# CITY OF ALBUQUERQUE

**RE: 10601 Easy St. NW - Addition  
Grading and Drainage Plan  
Engineer's Stamp Date: 10/13/22  
Hydrology File: A12D034**

ENGINEER'S SEAL  10/13/22	10601 EASY STREET	DRAWN BY: WCVJ
	GRADING AND DRAINAGE PLAN	DATE: 10-13-22
 1606 CENTRAL AVENUE SE SUITE 201 ALBUQUERQUE, NM 87106 (505) 872-0393		20220072-LAYOUT-10-13-22
		SHEET #
DAVID SOULE P.E. #14522		JOB #
		20220072

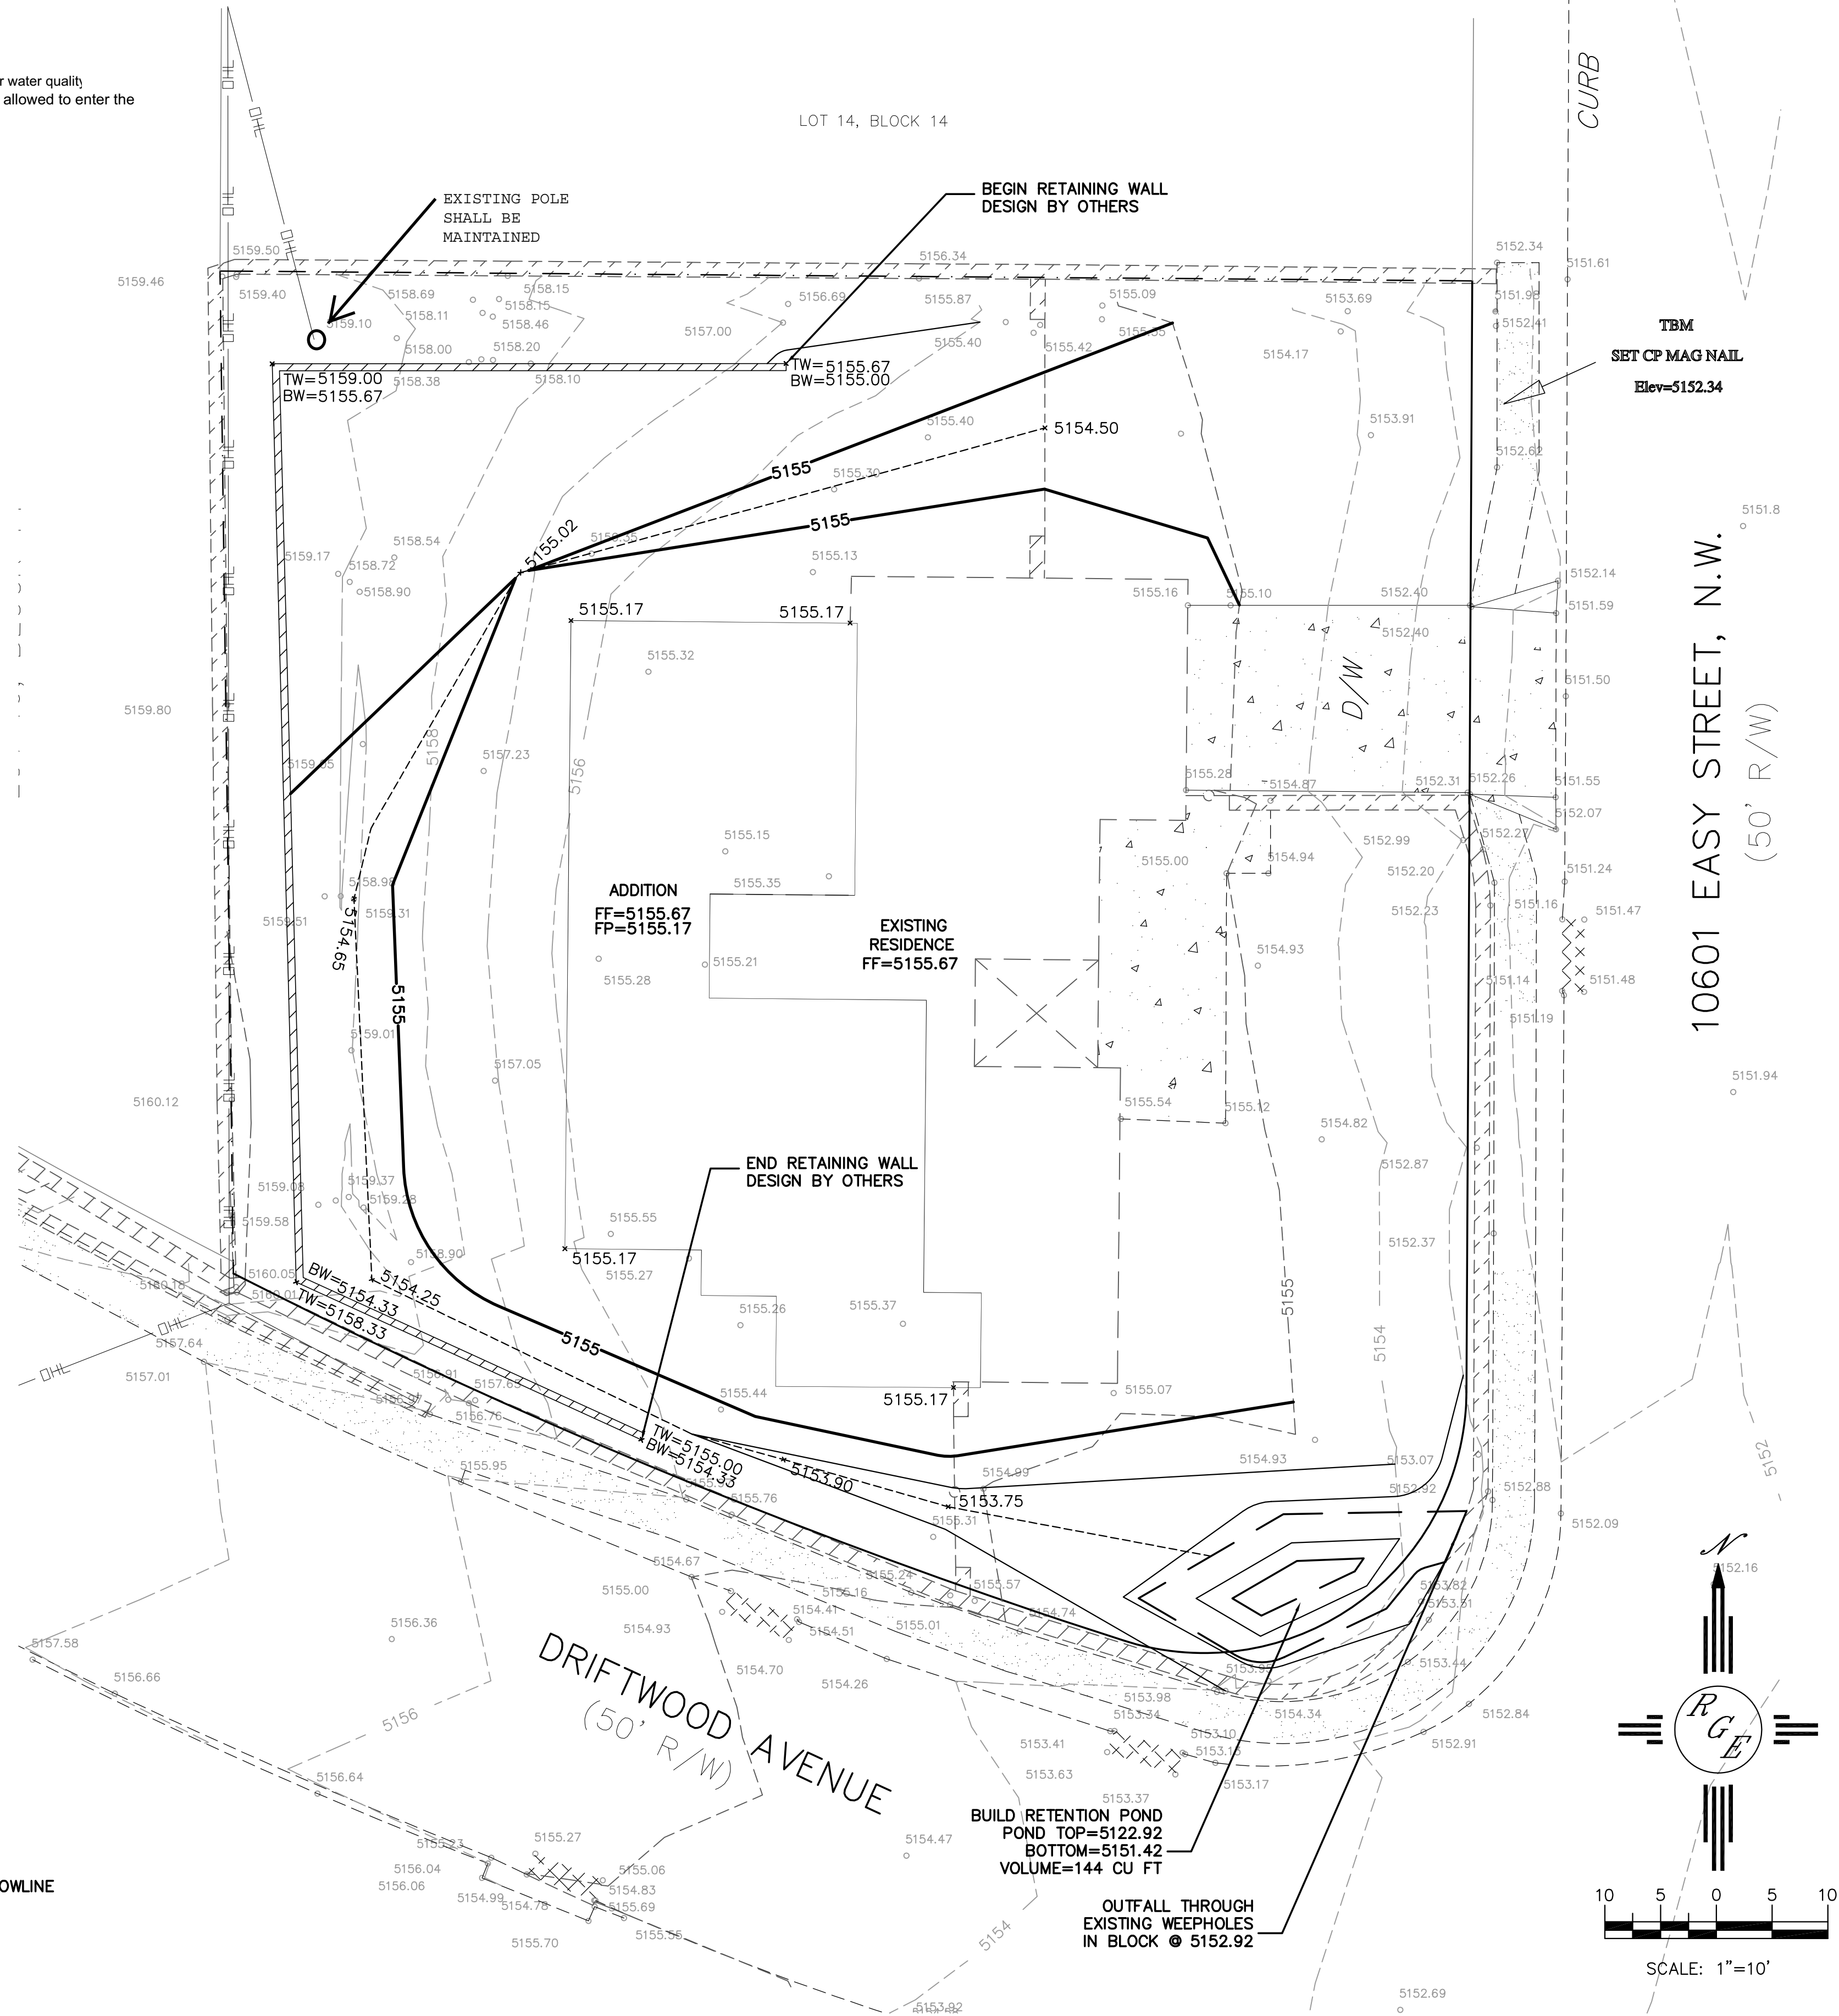
Based upon the information provided in your submittal received 10/13/2022, the Grading and Drainage Plan is approved for Building Permit and Grading Permit. Since this project is an addition to an existing house, a pad certification is not needed for this project. Please attach a copy of this approved plan in the construction sets for Building Permit processing along with a copy of this letter.

1. Engineer's Certification, per the DPM Part 6-14 (F): Engineer's Certification Checklist For Non-Subdivision is required.
